Common Structural Rules for Bulk Carriers and Oil Tankers

Rules for the Survey and Construction of Steel Ships
Part CSR-B&T **2017 AMENDMENT NO.2**

Rule No.92 25 December 2017
Resolved by Technical Committee on 26 July 2017

AMENDMENT TO THE RULES FOR THE SURVEY AND CONSTRUCTION OF STEEL SHIPS

Fig. 21 Dimensions of a Corrugated Bulkhead

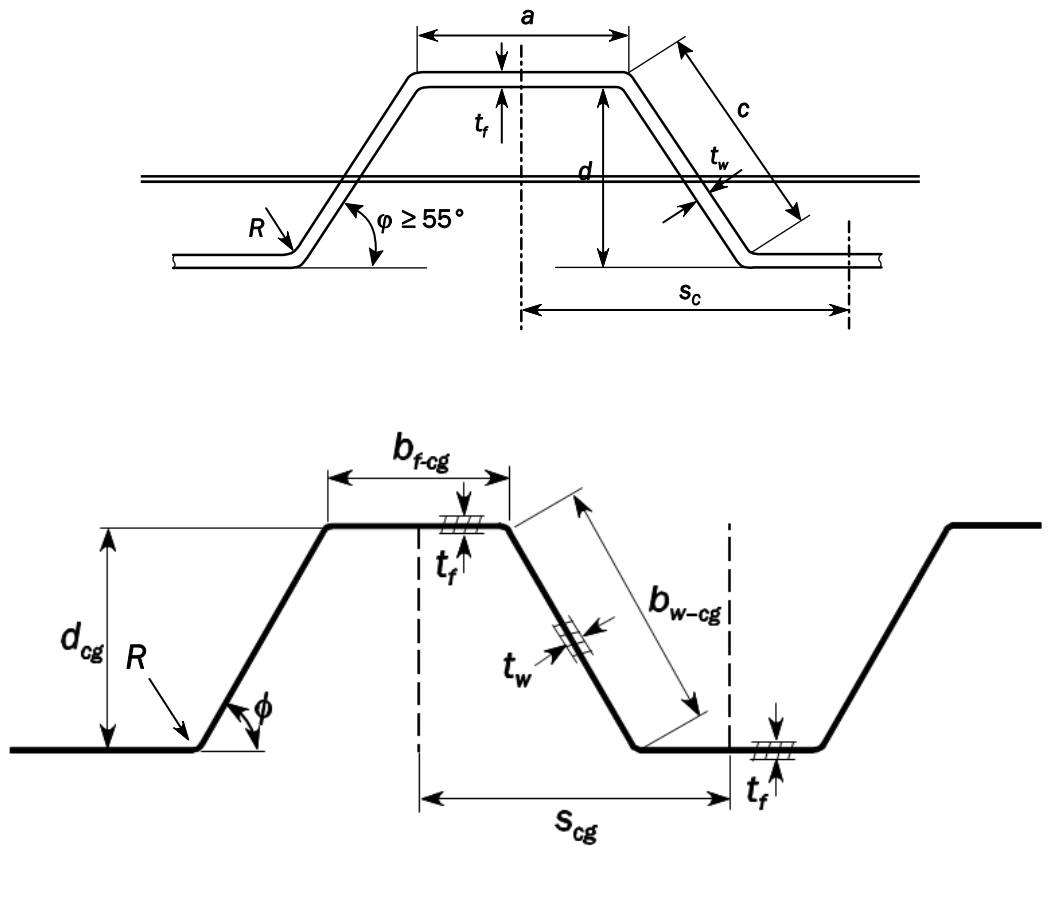
The main dimensions b_{f-cg} , R , b_{w-cg} , d_{cg} , t_f , t_w , s_{cg} of corrugated bulkheads are defined in **Fig. 21**.

The corrugation angle ϕ is not to be less than 55 degrees.

When welds in a direction parallel to the bend axis are provided in the zone of the bend, the welding procedures are to be submitted to the Society for approval.

Fig. 13 Sloshing Pressure Distribution on Transverse Stringers and Web Frames

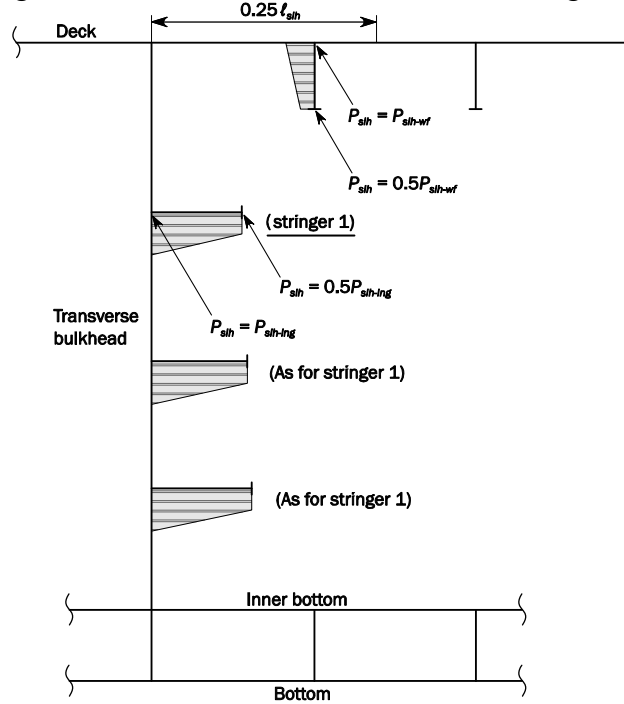
Fig.13 has been amended as follows.

Fig. 14 Sloshing Pressure Distribution on Longitudinal Stringers and Girders

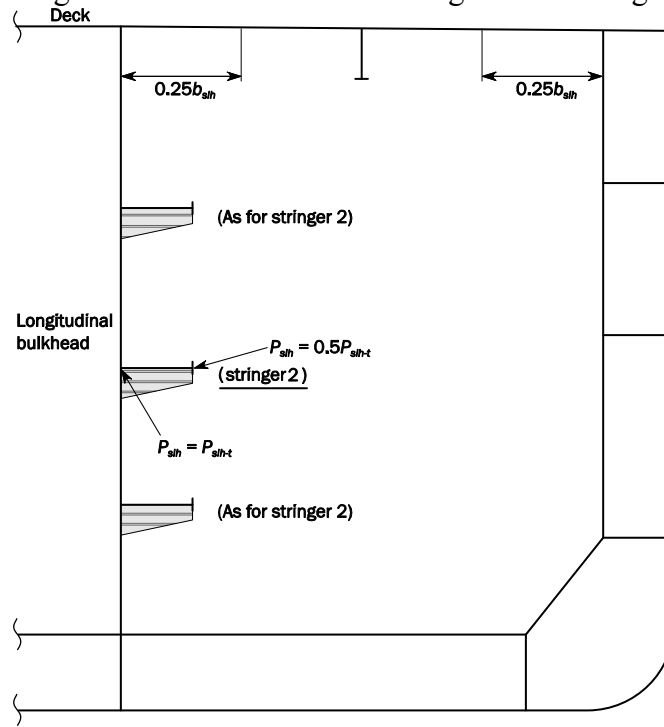
Fig.14 has been amended as follows.

Table 57 Shear Force Distribution Factor for Oil Tanker

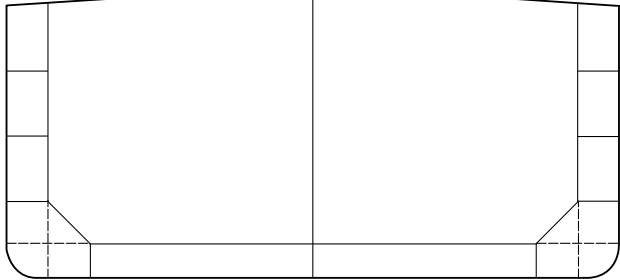
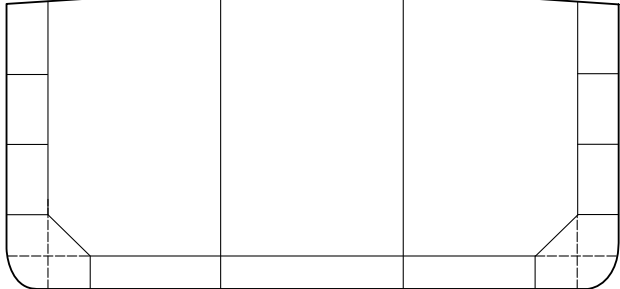
Table 5 has been renumbered to Table 7, and Table 6 and Table 7 have been renumbered to Table 5 and Table 6.

Hull configuration	f_3 factor
<p>One centreline bulkhead</p> 	$f_3 = 0.504 - 0.076 \frac{A_{1-n50}}{A_{2-n50}} - 0.156 \frac{A_{2-n50}}{A_{3-n50}}$
<p>Two longitudinal bulkheads</p> 	$f_3 = 0.353 - 0.049 \frac{A_{1-n50}}{A_{2-n50}} - 0.095 \frac{A_{2-n50}}{A_{3-n50}}$
<p>where: A_{1-n50}, A_{2-n50}, A_{3-n50}: Net projected area onto the vertical plane based on net thickness, t_{n50}, of the side shell, inner hull or the longitudinal bulkhead respectively, at one side of the section under consideration. The area A_{1-n50} includes the net plating area of the side shell, including the bilge. The area A_{2-n50} includes the net plating area of the inner hull, including the hopper side and the outboard girder under. The Area A_{3-n50} includes the net plating area of the longitudinal bulkheads, including the double bottom girders in line. The area A_{3-n50} for the centreline bulkhead is not to be reduced for symmetry around the centreline. When the longitudinal bulkhead is made with corrugation, A_{3-n50} is to consider the equivalent net thickness of the corrugation as defined in 3.4.6.</p>

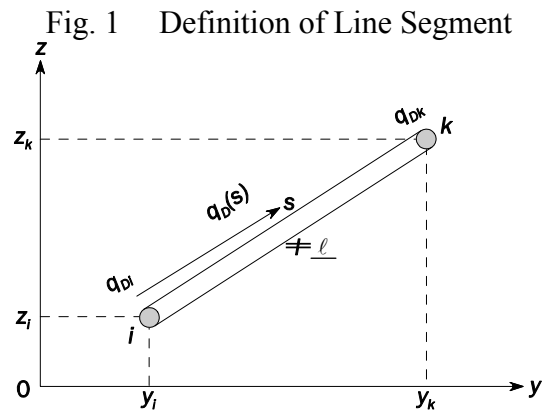
Fig. 1 has been amended as follows.

Table 7 Cross Sectional Properties

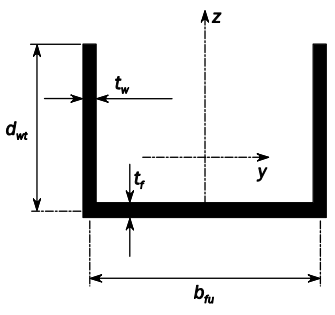
Table 7 has been amended as follows.

(Omitted)		
	$I_{sv-HSO} = \frac{1}{3} (b_{fu} t_f^3 + 2 d_{wt} t_w^3) 10^{-4}$ $I_{sv} = \frac{1}{3} (b_{fu} t_f^3 + 2 d_{wt} t_w^3) 10^{-4}$	cm^4
	$y_0 = 0$	cm
	$z_0 = -\frac{d_{wt}^2 t_w 10^{-1}}{2 d_{wt} t_w + b_{fu} t_f} - \frac{0.5 d_{wt}^2 t_w 10^{-1}}{d_{wt} t_w + b_{fu} t_f / 6}$	cm
	$c_{warp} = \frac{b_{fu}^2 d_{wt}^3 t_w (3 d_{wt} t_w + 2 b_{fu} t_f)}{12 (6 d_{wt} t_w + b_{fu} t_f)} 10^{-6}$	cm^6
(Omitted)		
<p>Note 1: All dimensions are in <i>mm</i>.</p> <p>Note 2: Cross sectional properties are given for typical cross sections. Properties for other cross sections are to be determined by direct calculation.</p>

Table 5 Design Standard E – Hopper Knuckle Connection Detail, Welded, Bulk Carrier

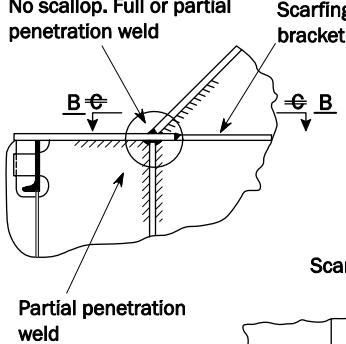
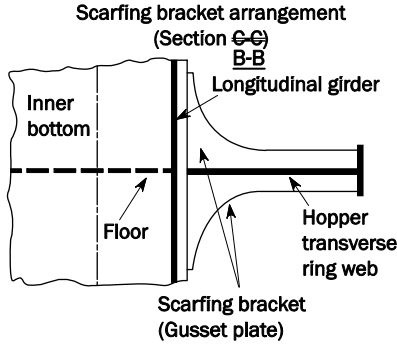
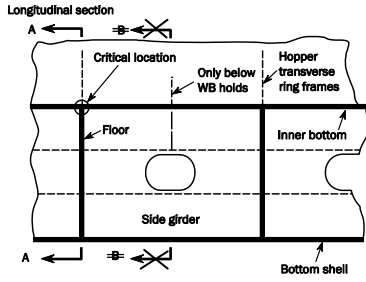
Table 5 has been amended as follows.

Connections of floors in double bottom tanks to hopper tanks Welded knuckle connection of hopper tank sloping plating to inner bottom plating	
Critical areas	Design standard E
	<p>a) Improvement at the knuckles</p> <p>No scallop. Full or partial penetration weld</p> <p>Scarfing bracket</p>  <p>Partial penetration weld</p> <p>Scarfing bracket arrangement (Section A-A) B-B</p>  <p>Inner bottom</p> <p>Floor</p> <p>Longitudinal girder</p> <p>Hopper transverse ring web</p> <p>Scarfing bracket (Gusset plate)</p>
Critical locations	
<p>Longitudinal section</p>  <p>Critical location</p> <p>Only below WB holds</p> <p>Hopper transverse ring frames</p> <p>Inner bottom</p> <p>Floor</p> <p>Side girder</p> <p>Bottom shell</p> <p>Transverse section A-A</p>  <p>Critical location</p> <p>Inner bottom</p> <p>Longitudinal girder</p> <p>Floor</p> <p>Hopper transverse ring web frame</p>	
(Omitted)

Fig. 1 Machinery Foundations Type 1

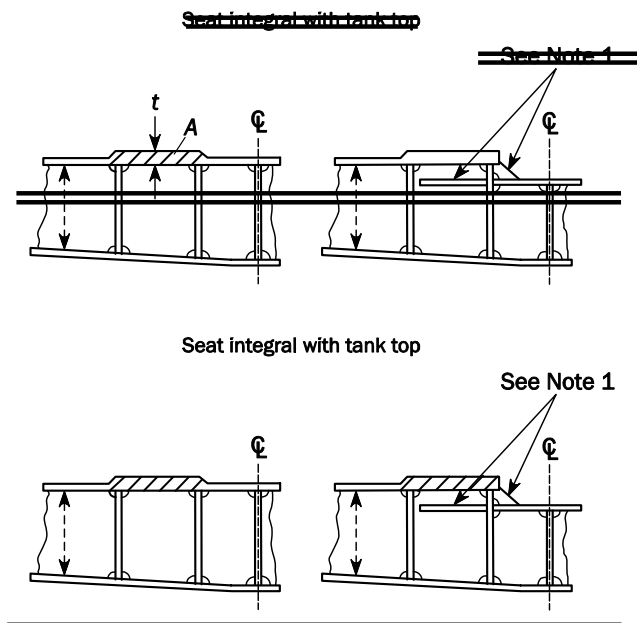
Fig. 1 has been amended as follows.

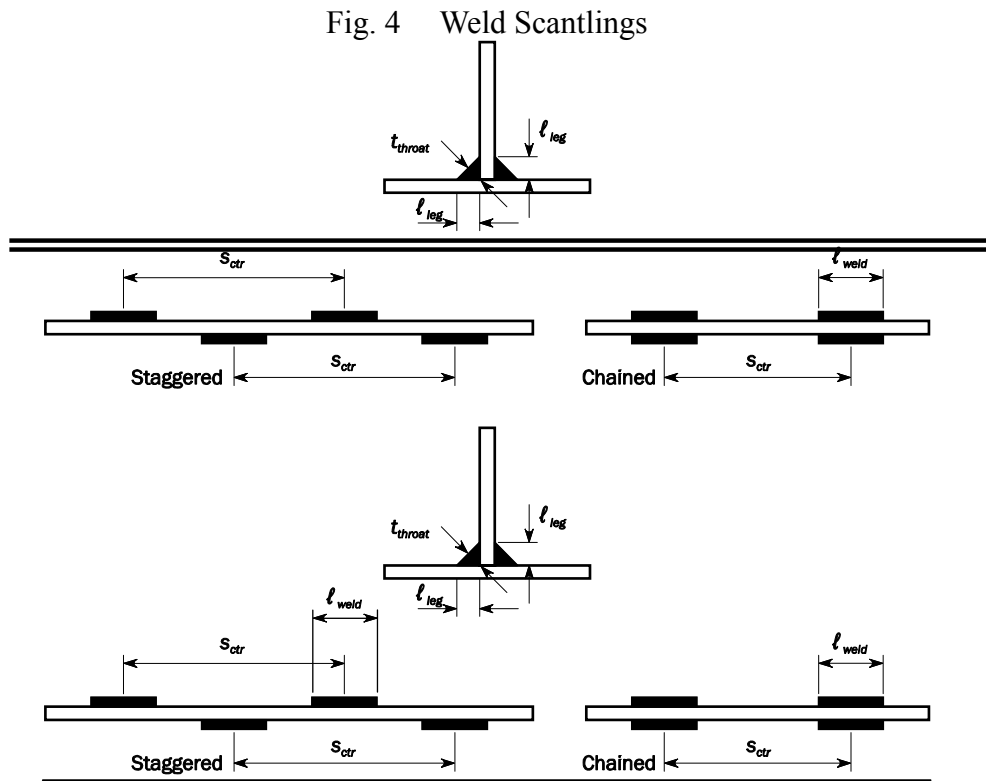
Fig. 4 has been amended as follows.

Fig. 1 Example of Hatch Cover Fitted with U Type Stiffener

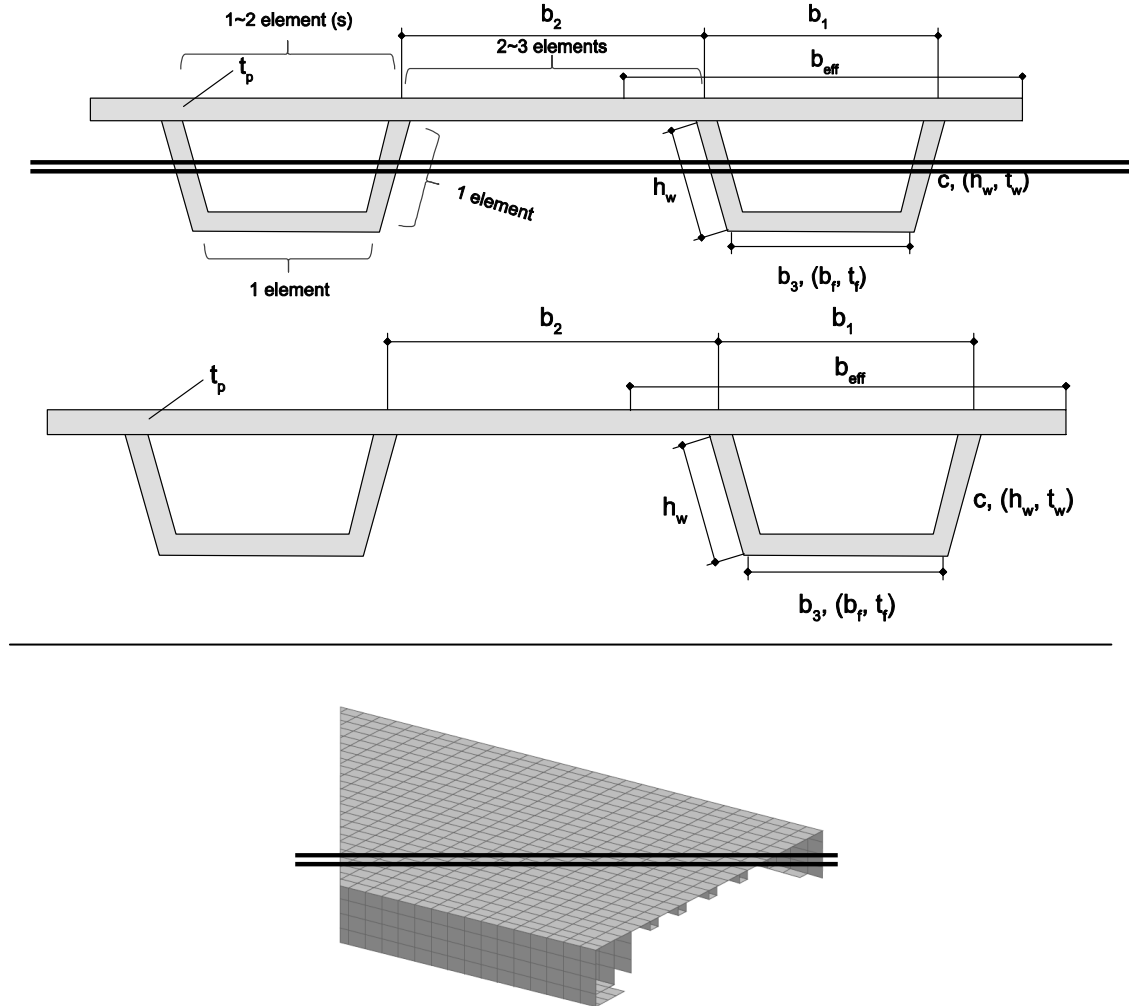
Fig. 1 has been amended as follows.
